**Sent:** 12/05/2020 8:12:59 AM  
**Subject:** Submission against DA2020 0347  
**Attachments:** DA2020 0347 submission.pdf;

**RE: DA2020/0347 – New Seniors Housing Units with Basement Parking Development Application at 49 Forest Way, FRENCHS FOREST NSW 2086**

Extract from DA submitted plans showing location of breach of DCP height requirements due to Basement garage and building form not being stepped to the slope of the land.

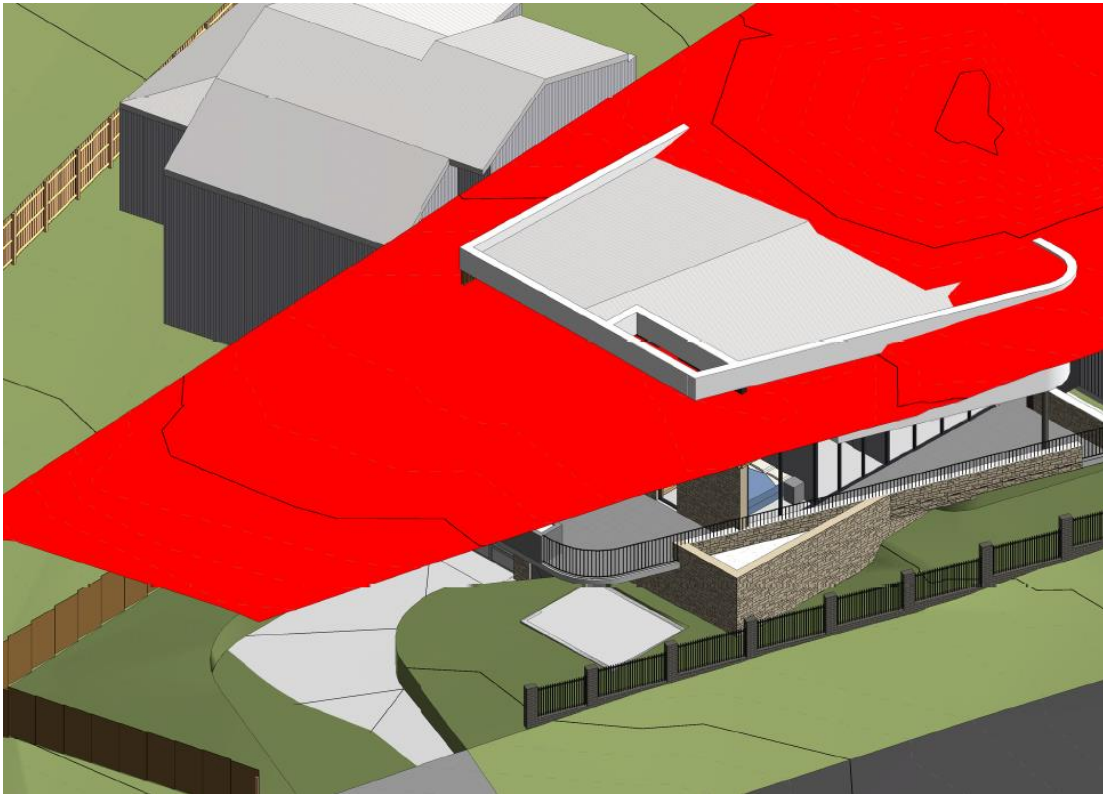
The proposed development being located on an elevated corner block is visually prominent and will have the appearance of a multi-unit residential development with long facades to the Adams Street frontage and a two and a half storey appearance when viewed from the east due to excessive height which breaches DCP wall height plane. I note the complete lack of RL's on the section drawings with regards to parapet and ceiling heights, and that there are no ground levels or floor RL's in the submitted plans. I question why this information has not been provided and urge Council to insist upon its provision in accordance with documentation standards required to assess development. Using the survey information provided and scaling sections using Bluebeam software to provide accuracy, the east façade sits at existing ground RL of 149,300. The proposed ceiling height (measured – not declared) is RL 156,700. The building wall/ceiling height is therefore 7.7m ie. a half meter breach of DCP height requirement. The compliance table on the cover page of the drawings claims DCP height complies but it is in breach. This breach in height creates increased overshadowing of 47 Forest Way private open space and rear facing windows, and in actual fact extends all the way to 45 Forest Way.

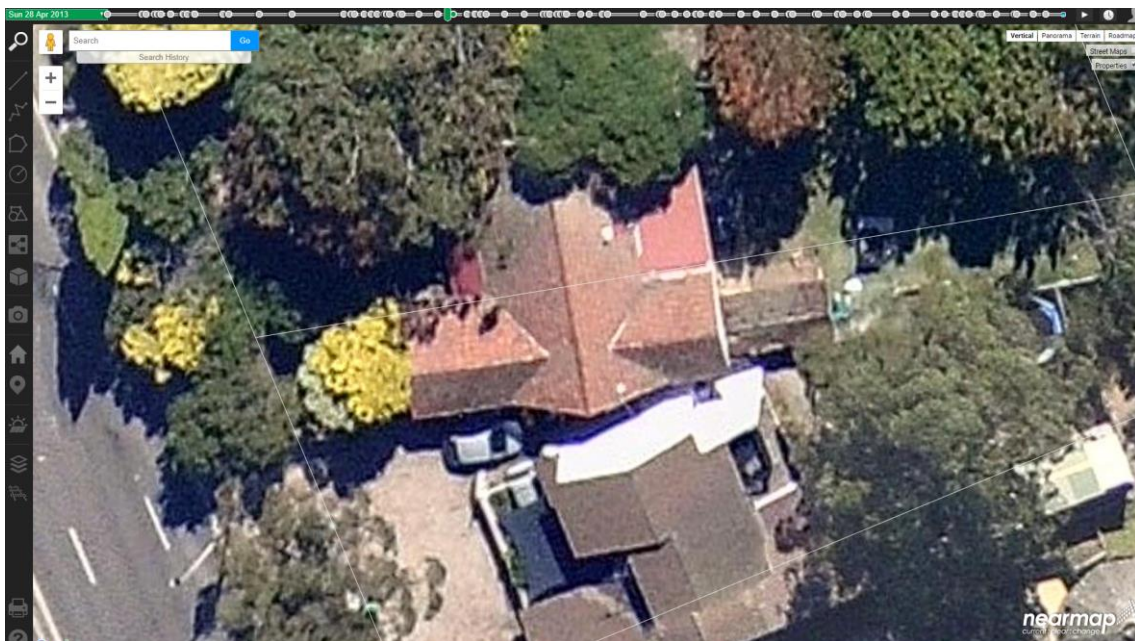
Contrary to the Statement of Environmental Effects and the Clause 4.6 in relation to lot size I would submit that overshadowing is a substantial concern should the proposed development be approved in its current form. Although this revised DA is an improvement on the very poorly considered previous application, the proposed development will still create increased overshadowing of both the private open space and the east facing living room windows of 47 Forest Way. The south eastern wall position of the proposed development is also the tallest wall element, and exceeds permitted DCP wall height due to basement carpark. This section of wall is still considerably further to the east than the existing residence at 49 Forest Way, noting that the small existing structure in the SE corner is only a single storey structure and stepped with ground plane/ The submitted shadow diagrams fail to take into consideration the two large existing eucalypt trees in the rear yard of 47 Forest Way (tree 16 identified in the arborist report and another larger eucalypt further to the west). These trees substantially shade and block early morning sun to the backyard private open space and ENE facing living room and bedroom windows such that the house is heavily reliant on later morning sun and early afternoon sun particularly through winter (from 10am to 1pm). As illustrated in the shadow diagrams the existing residence at 49 Forest Way casts no shadows on the east (backyard facing) façade or the backyard private open space between 12pm and 3pm. The proposed development will overshadow the east façade and backyard immediately outside the residence at 12pm and by 3pm the entire backyard is in shade whereas only half the backyard is shaded in the current situation.

The application purports that there is no impact on 47 Forest Way as they do not have any windows in their north façade. Rather than ameliorating an impact this substantially increases the impact of the development as 47 Forest Way is so heavily reliant on mid-morning to early afternoon sun to achieve acceptable light into their ENE facing windows and backyard.

The submitted Clause 4.6 cannot substantiate that there is no impact to 47 Forest Way in relation to overshadowing. Indeed the non compliance with the control means overshadowing extends all the way into the back yard of 45 Forest Way as well. There is clearly a significant loss of sunlight and amenity which is unacceptable.

47 & 49 Forest Way 28 April approximately Midday (and equinox) – note that the east façade of 47 Forest Way is enjoying full solar access due to its ENE orientation, and the backyard immediately outside rear façade of 47 Forest Way is also in full sun – image courtesy of Nearmap

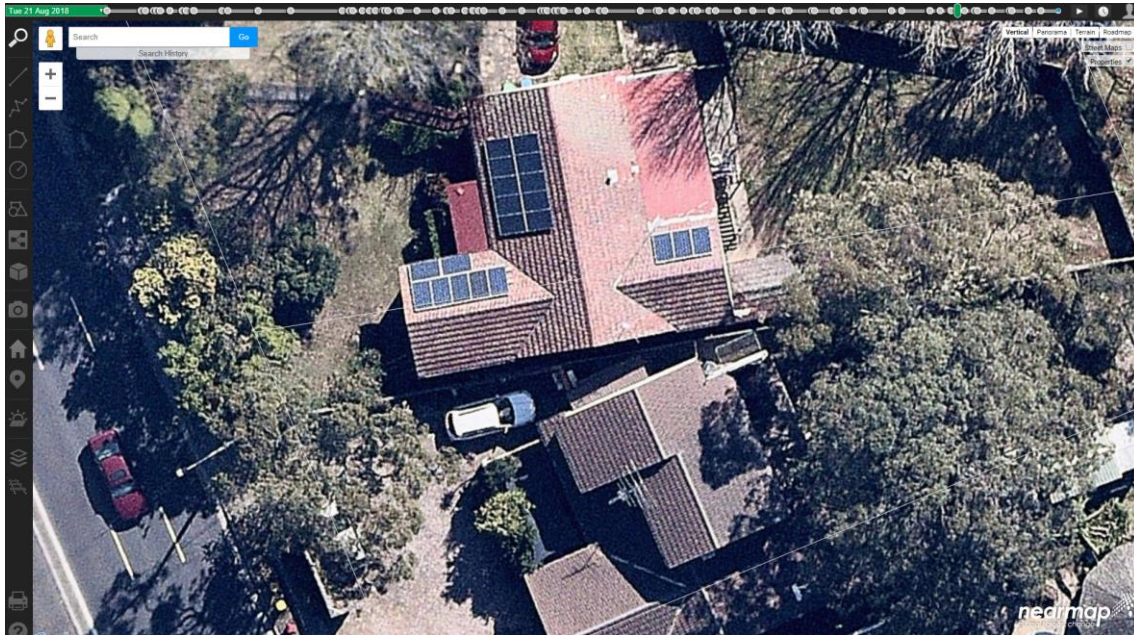
47 & 49 Forest Way 21 August approximately 9am (and one month after winter solstice) – note that the east façade of 47 Forest Way is fully shaded by the two large eucalypts in backyard, the only opportunity for solar gain in winter to east façade and backyard is between around 10am and just after midday. The proposed development of 49 Forest Way as a two and a half storey height will eliminate any possible solar gain to these ENE facing windows and the backyard private open space – image courtesy of Nearmap

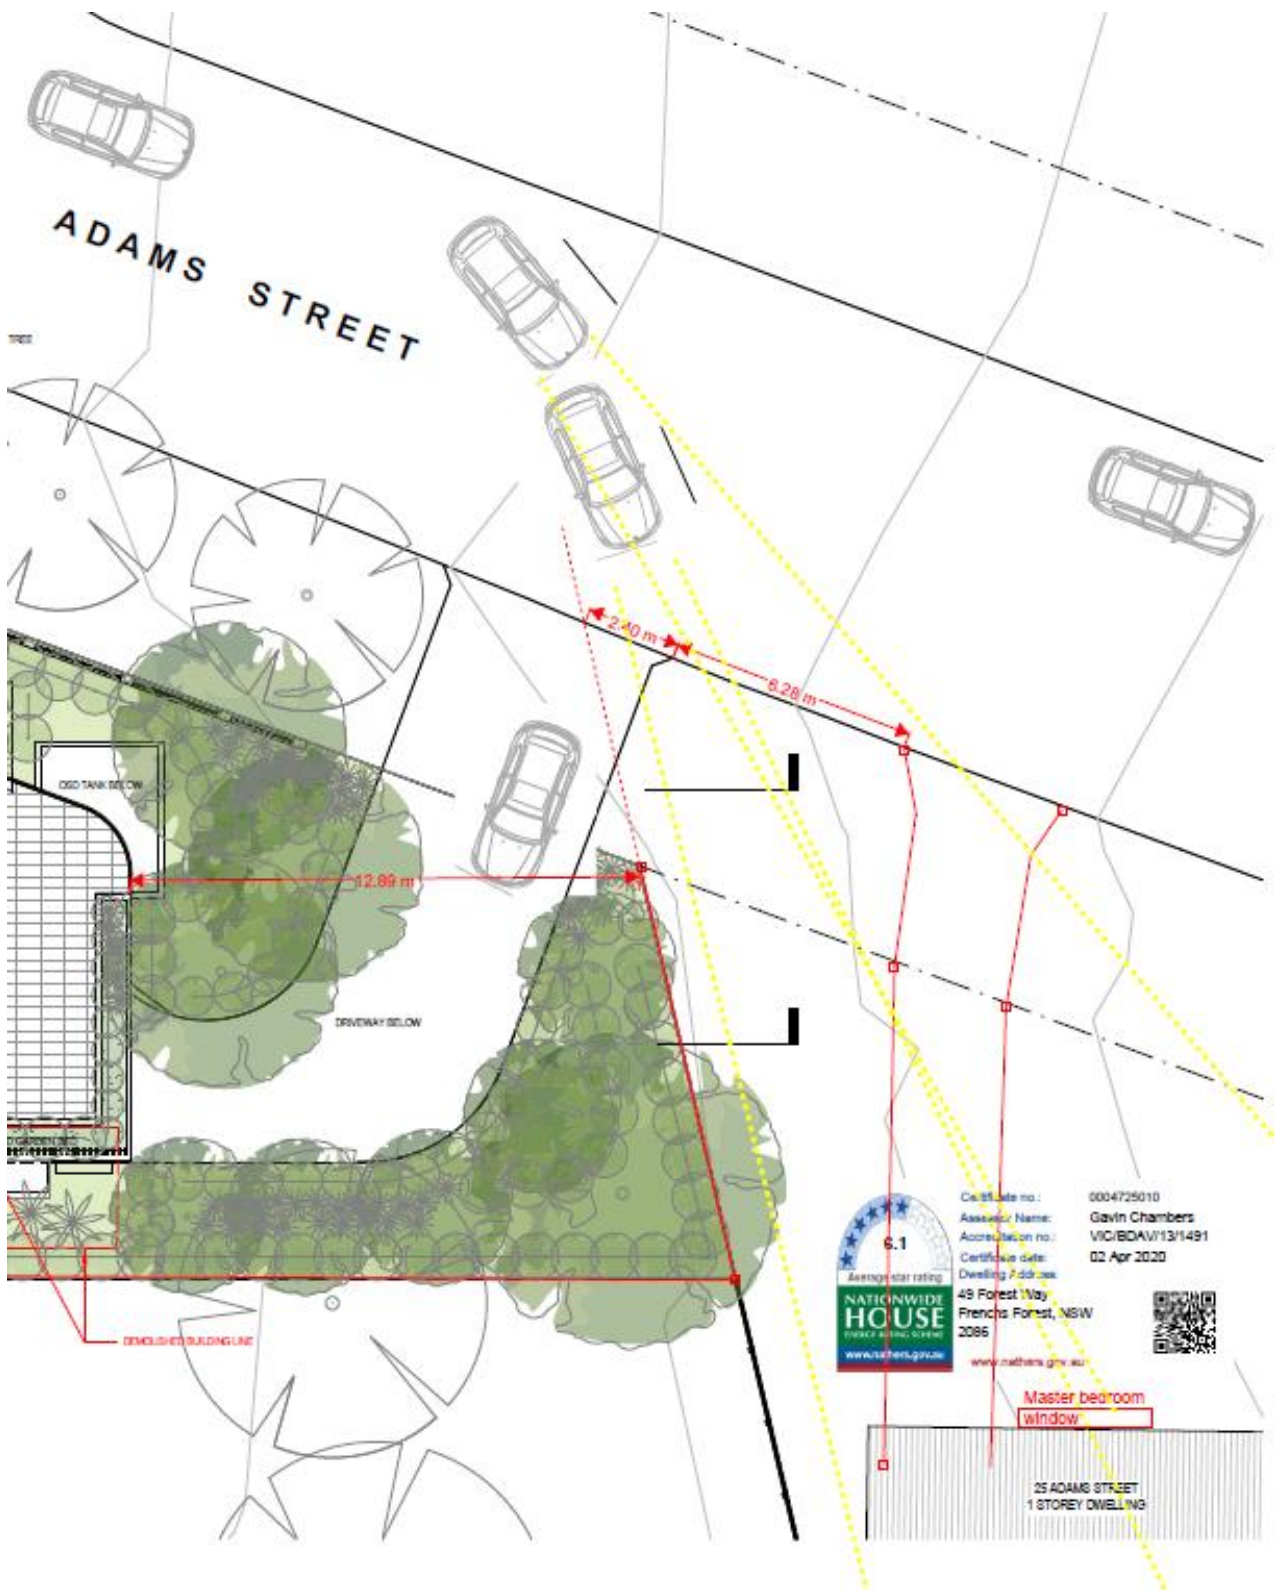
Of specific concern to us is the proximity of the proposed new driveway to our own driveway. We note that the site plans and traffic report have failed to show our driveway which is very close to the alignment of the proposed new driveway. The proposed driveway actually extends past our shared boundary by 2.4m, meaning that all cars entering from a westerly direction on Adams Street will be visible turning into our driveway, and at night time headlights will be directed straight at our master bedroom and living room. The side fence will offer no protection and we will have to endure constant disruption and likely interrupted sleep. The proximity of the driveway will also further exacerbate the issues that we currently have getting into and out of our property.

Red line is a projection of our shared boundary to street kerb. Blue line and watering can represents proposed location of the eastern edge of new driveway – 2.4m past the line of our boundary fence and only 6m from our driveway crossover. Headlights of vehicles turning into the driveway will be clearly visible from our bedroom and living areas with no fence blocking the light or sound.

Extract from Ground Floor Plan amended and scaled in Bluebeam. Our driveway superimposed in red onto plan (not shown in submitted drawings). Vehicles turning into driveway from west will direct headlights through master bedroom and living room windows. Driveway extends 2.4m past our shared boundary position, driveway only 6m from our driveway.

Should the development proceed the driveway entry must be moved west closer to its current kerb crossing alignment to avoid conflict with our property and also negate the requirement to remove the beautiful street trees that we enjoy and are so much part of the local street character. It is not adequate for the applicant to rely on removal of street trees and place a driveway wherever they see fit. The street trees are a real site constraint and the planning should consider them accordingly. Replacing a 20 year old mature tree with a 100L potted tree that will take decades to reach a similar height is not a reasonable outcome. The SEPP 2004 Clause 33, Chapter 3 Part 3 Division 2 states **(f) retain, wherever reasonable, major existing trees.**

Proposed driveway location should be moved further west to align with the existing "Keep Clear" zone marked on Adams Street and trees 1 and 2 should not be removed.
